P&Z STAFF REPORT

Board of Appeals Meeting, March 4, 2020

Cases: **V19-0031 & V19-0032 – 0 Glenridge Drive (Parcel # 17 0034 LL0096)**
Staff Contact: Madalyn Smith (msmith@sandyspringsga.gov)
Report Date: February 26, 2020

V19-0031 is a request for a Variance from Sec. 9.2.4.A. of the Development Code for encroachments into the 50-foot undisturbed natural vegetative buffer and 25-foot additional impervious surface setback for the purposes of constructing a restaurant, driveway, event lawn, and walking paths in association with a proposed hotel at 0 Glenridge Drive (Parcel # 17 0034 LL0096).

Figure 1.

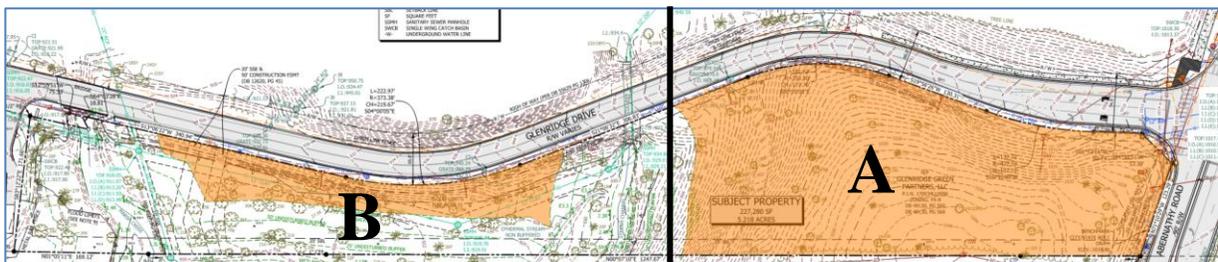
The areas of the site unencumbered by state waters buffers are highlighted in orange on Figure 1 below. The front half of the property, labeled "A," is ~2.6 acres and is where the hotel is proposed to be located. The rear portion of the property, "B," is ~2.6 acres and is the proposed location of the restaurant, driveway, event lawn, and walking trails for which the applicant requests a Variance. These sites are being developed separately but are being viewed as one overall development scenario.

Figure 2.

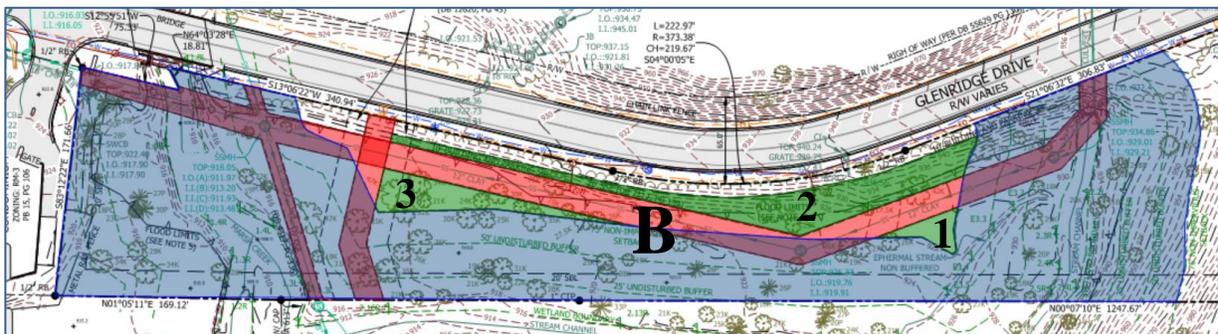
The buildable area of portion "B" is significantly reduced by a Fulton County sanitary sewer easement, though the applicant does have an understanding with Fulton County that would allow them to locate a portion of the proposed deck and driveway over the easement. Figure 2 shows the state waters buffers in blue, the easement in red, and the three (3) separate buildable areas in green, labelled 1-3. Area 1 is ~870 square feet, area 2 is ~6,600 square feet, and area 3 is ~2,150 square feet. The buildable area of portion B is reduced to 9%, or 9,620 square feet, of a 2.6 acres site.

The presence of the buffers does not eliminate the possibility of development on this portion of the property but it is severely limited by the long and narrow shape, two streams, and the sanitary sewer easements.

Figure 5. Proposed Site Plan

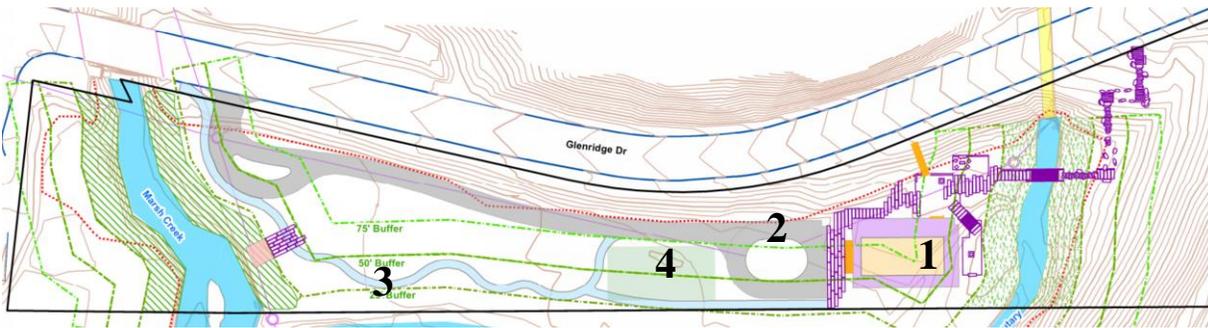
Finding: Below is the proposed site plan, with the various improvements labeled 1-4.

(1) Impervious intrusions for “Biergarten Building” and “Biergarten Deck”*

Buffer/Impervious Setback	Encroachment (square feet)
25' Additional Impervious Surface Setback	2,369
50' City Undisturbed Natural Vegetative Buffer	434
25' State Undisturbed Natural Vegetative Buffer	0
<i>Total</i>	<i>2,903</i>

(2) Pervious intrusions for driveway*

Buffer/Impervious Setback	Encroachment (square feet)
25' Impervious Setback	2,500
50' City Undisturbed Buffer	1,694
25' State Undisturbed Buffer	0
<i>Total</i>	<i>4,194</i>

(3) Pervious intrusions for footpath

Buffer/Impervious Setback	Encroachment (square feet)
25' Impervious Setback	240
50' City Undisturbed Buffer	3,587
25' State Undisturbed Buffer	0
<i>Total</i>	<i>3,827</i>

(4) Pervious intrusions for event lawn

Buffer/Impervious Setback	Encroachment (square feet)
25' Impervious Setback	1,682
50' City Undisturbed Buffer	1,520
25' State Undisturbed Buffer	0
<i>Total</i>	<i>3,202</i>

3. The proposed deck is listed as Pervious Surface in the application. The applicant should provide sufficient plans, detail and supporting data, as determined by the Director, to support classification of the deck as pervious surfacing at the time of permitting.

4. The proposed vehicular driveways and pedestrian walkways are shown on the plan as Pervious Surfaces. The applicant should provide sufficient plans, details and supporting data, as determined by the Director that the proposed surfaces will provide infiltration equivalent to natural pervious surfaces at the time of permitting,

1. The intrusion be limited to and substantially similar to that shown in “Figure 1: Proposed Site Plan” prepared by Kimley Horn and “BIERGARTEN SITE PLAN – D.C. – 6.1.2A – PREFERRED PLAN” prepared by Cooper Carry; both received on February 14, 2020.

Figure 9. Proposed Plan

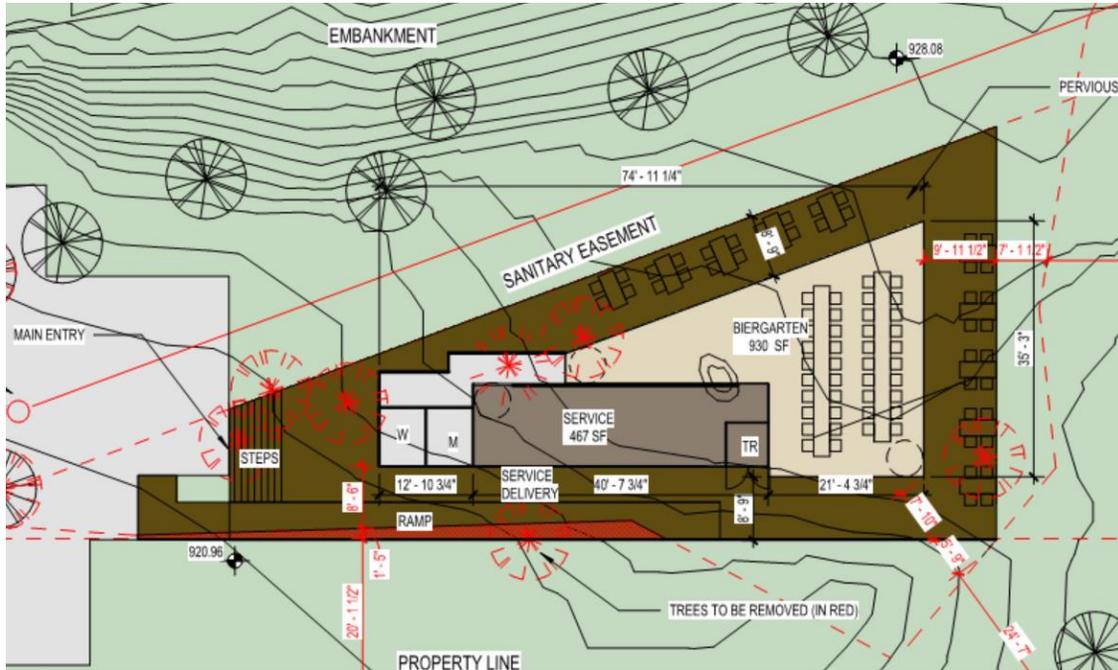
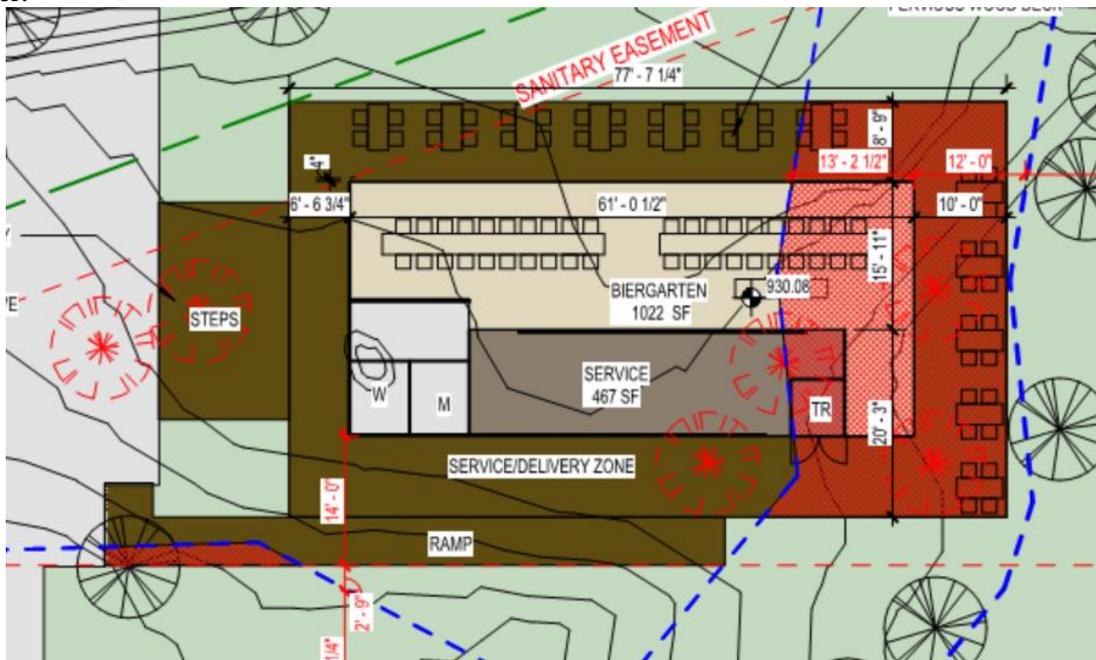
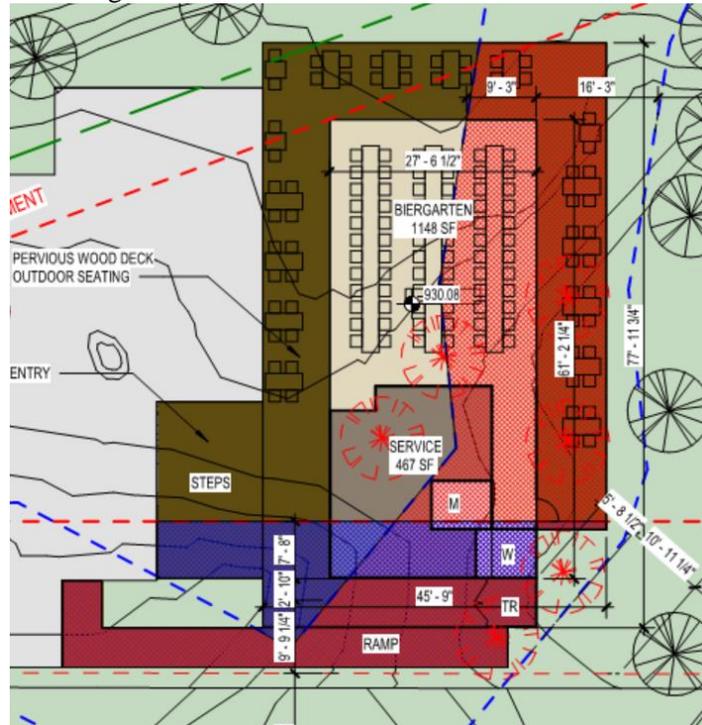
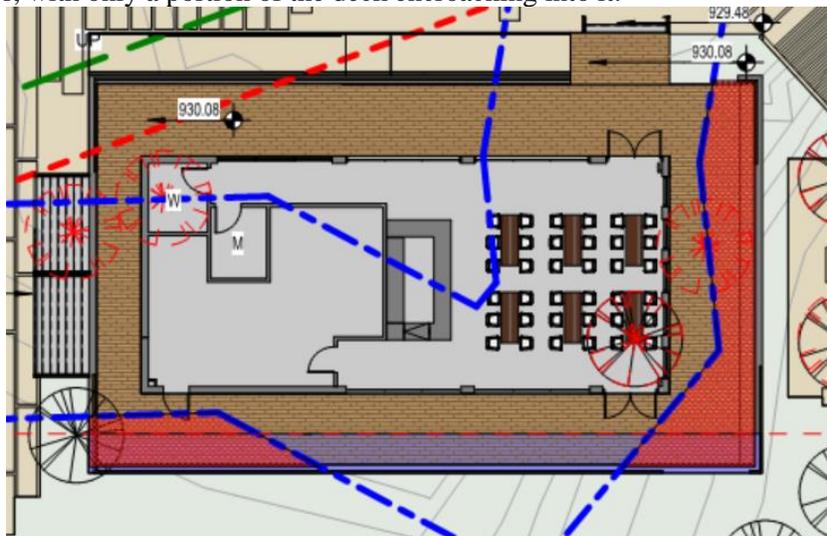
Alternate 1 shows no intrusion within the 50-foot undisturbed natural vegetative buffer, but the building would not be functional.

Alternate 2 proposes 1,104 square feet of encroachment into the 50-foot undisturbed natural vegetative buffer.

Alternate 3, the applicant's previous preferred request, shows 2,021 square feet of disturbance within the 50-foot undisturbed natural vegetative buffer.

The current plan the applicant has proposed, limits intrusion into the 50-foot undisturbed natural vegetative buffer, with only a portion of the deck encroaching into it.

Alternate 1 does not appear viable due to the awkward shape of the building. Alternatives 2 and 3 do not adequately protect the buffers and the 25-foot additional impervious surface setback, and thus are not the minimal relief necessary.

5. The alternatives presented failed to consider relocation of the existing sanitary sewer line as an option.
6. It appears that full compliance with Development Code Section 9.6 may not be possible with the Site Plan as submitted. If approved, the plans and studies should be required to fully comply with Development Code Section 9.6 and the Georgia Stormwater Management Manual.
